LUPC Staff Report For Chevron Convenience Store

Project Address: 251 South Lincoln Boulevard

Case Numbers: ZA-2013-3814-ZV-CDP-CU-CUB-SPP-CDO;
ENV- 2013-3815-EAF

SIGN-02

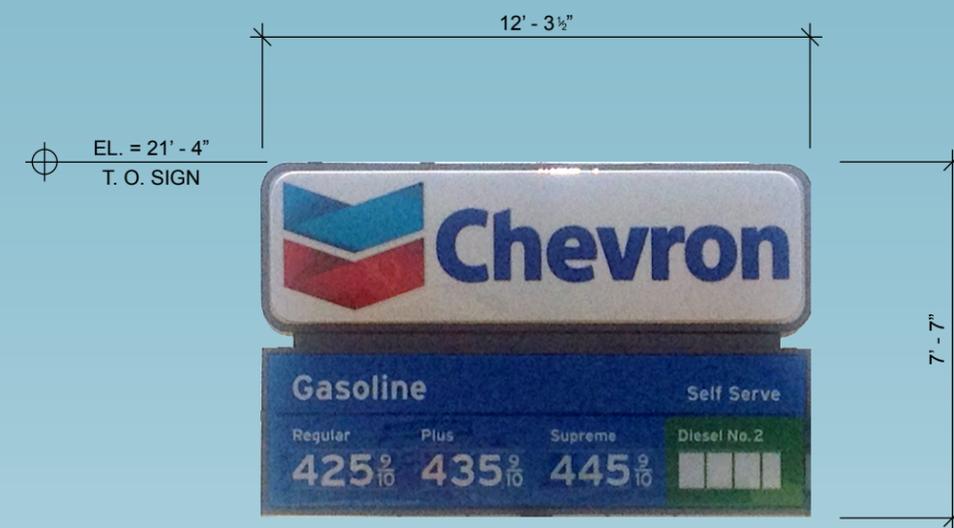
1. Removal of the three pole signs so that the property is in compliance with the Lincoln Boulevard Community Design Overlay District ordinance (“CDO”) [Q] Condition 10.a., and LAMC 12.22A.28(A)(6)(i), and installation of one pedestrian-oriented sign with the gasoline branding and prices, identical to the pedestrian-oriented gas station signs permitted in Santa Monica. If the City Department Of Transportation determines that this type of pedestrian-oriented sign is impossible at the corner of Lincoln and Rose due to driver line-of-sight requirements, and so long as the other two existing pole signs are permanently removed, the VNC recommends approval of a variance to [Q] Condition 10.b. and a conditional use pursuant LAMC 12.22W.4, to allow the applicant to modify one existing pole sign, which shall be modified in substantial conformance with pages Sign-02 and Sign-05 of the drawings submitted with the application and marked Exhibit “A.”

SIGN-04

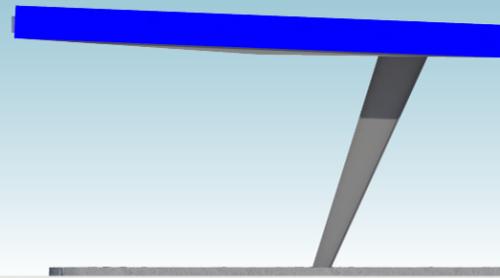
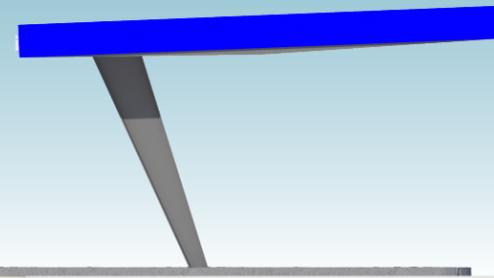
2. The only other signs on the property shall be two non-illuminated gasoline branding signs on the canopy as proposed on page Sign-04 of Exhibit “A.” There shall be no other signs, banners, logos, branding, or advertising of any kind on the windows or exterior walls of the convenience store, and the applicant shall record a covenant in the form attached as Exhibit “B” relating, in part, to signage.
